REMARKS/ARGUMENTS

Appl. No. 10/625,102
Amdt. dated Oct. 19, 2005
Reply to Office Action of July 22, 2005

Fig. 3A

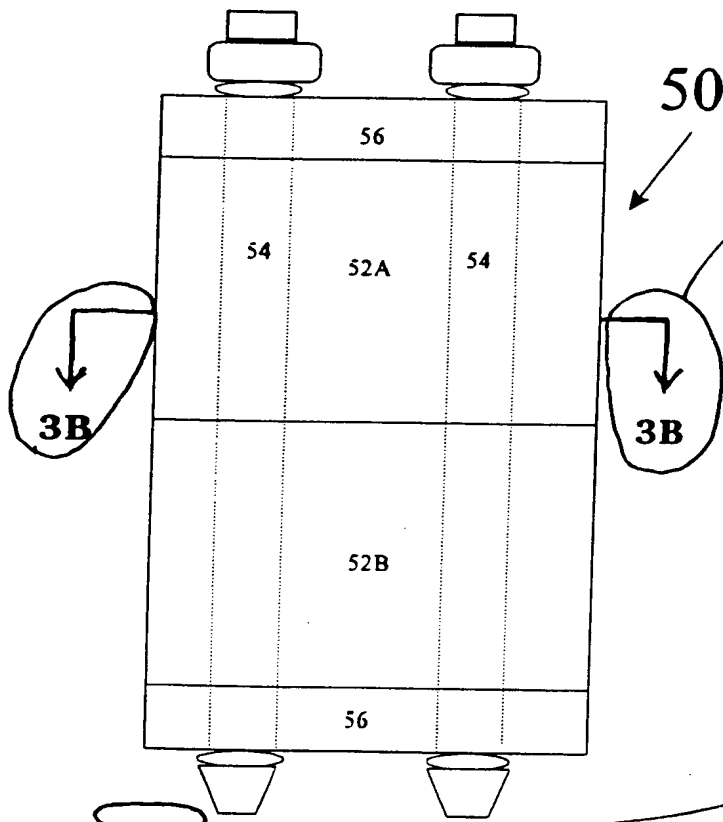
In amended FIG. 3A, the number “244103.1” at the bottom of the figure has been deleted, and appropriate labels and arrows for cross-sectioning line 3B-3B have been added.

In the July 22, 2005 Office Action, the Examiner requires that the number "244103.1" at the bottom of FIG. 3A and FIG. 5A be deleted. In response, Applicant respectfully submits replacement sheets, as well as an annotated marked-up copy showing change, for revised FIGS. 3A and 5A, in which the number "244103.1" at the bottom of these figures has been deleted.

The Examiner also requires that line 3B-3B, line 4B-4B and line 5B-5B be shown in FIGS. 3A, 4A and 5A, respectively, to show where the cross-sections for FIGS. 3B, 4B and 5B are coming from. In response, Applicant respectfully submits replacement sheets, as well as annotated marked-up copy showing change, for revised FIGS. 3A, 4A and 5A showing line 3B-3B, line 4B-4B and line 5B-5B, respectively.

the number "294103.1"
deleted

Fig. 4A

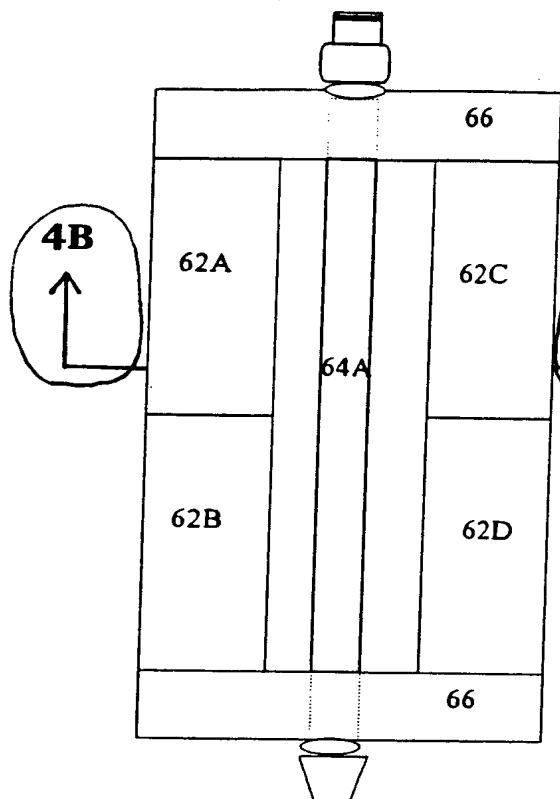
In amended FIG. 4A, appropriate labels and arrows for cross-sectioning line 4B-4B have been added.

Fig. 5A

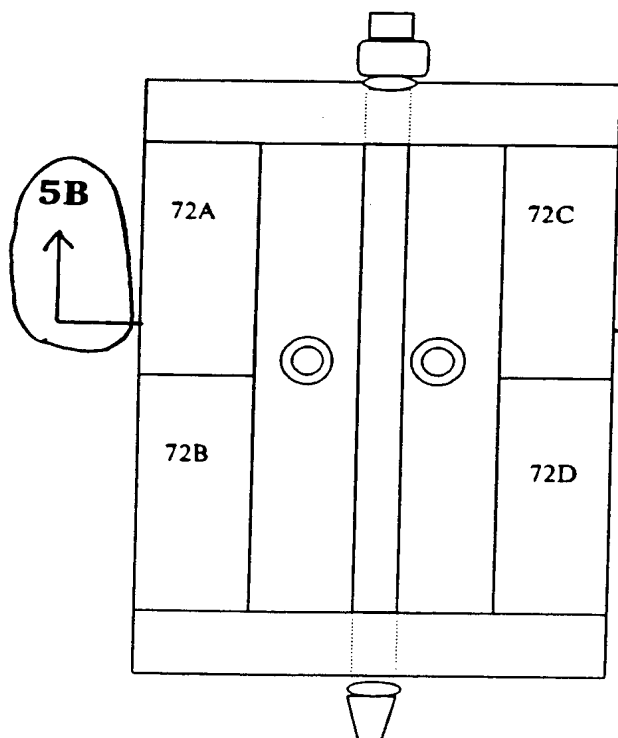
In amended FIG. 5A, the number “244103.1” at the bottom of the figure has been deleted, and appropriate labels and arrows for cross-sectioning line 5B-5B have been added.

the number "244103.1" deleted

Fig. 6

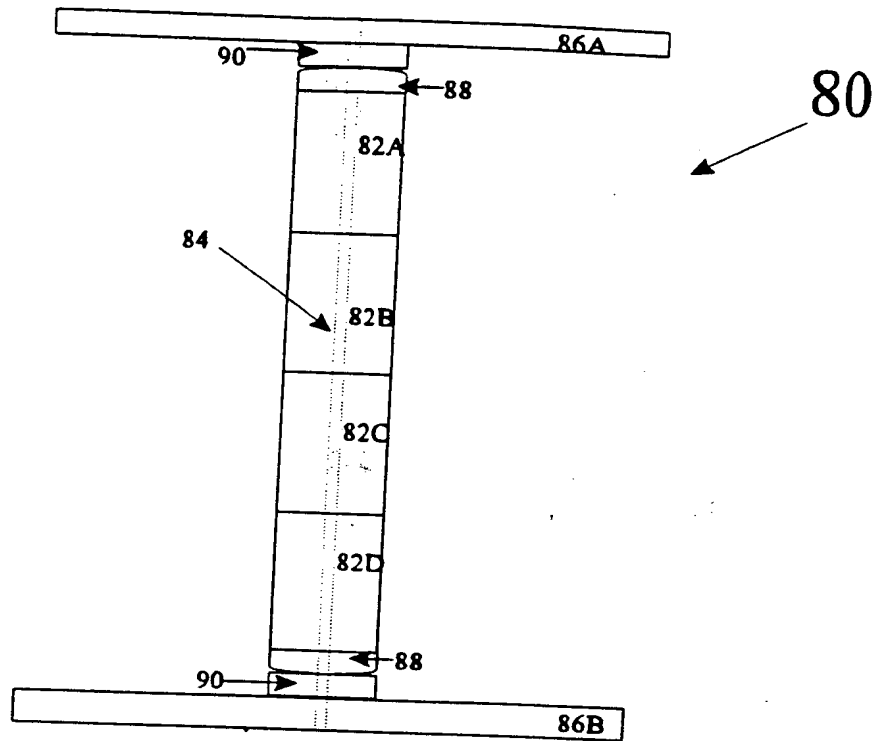
The paragraph [0057] of the specification has been amended to include the description of reference numeral 88 shown in FIG. 6, which was inadvertently omitted previously. In view of the statement at the end of this paragraph that "this embodiment

In addition, the Examiner objected to the drawings because reference numeral 88 shown in FIG. 6 does not appear to be described in the specification. In response, the Applicant has amended the paragraph [0057] of the specification to add in the description the reference numeral 88 shown in FIG. 6, which was inadvertently omitted previously. In view of the statement at the end of the paragraph [0057] that "this embodiment can be further modified in accordance with the teachings and principles

Fig. 7

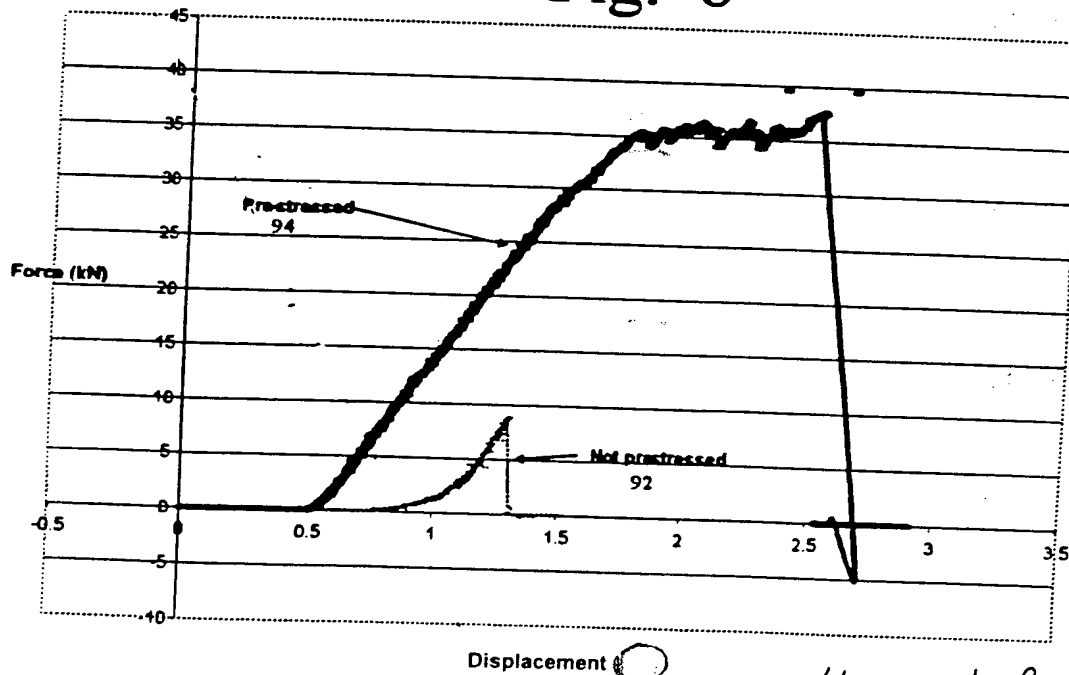
In amended FIG. 7, the unit for displacement in parentheses, (mm), has been deleted. It is respectfully submitted that, while the displacement values in FIG. 7 are indicative of the measure of strain, the numerical values for displacement as shown in

FIG. 7 are provided only for the purpose of comparison between the prestressed and non-prestressed results.

the unit for displacement,
(mm), deleted
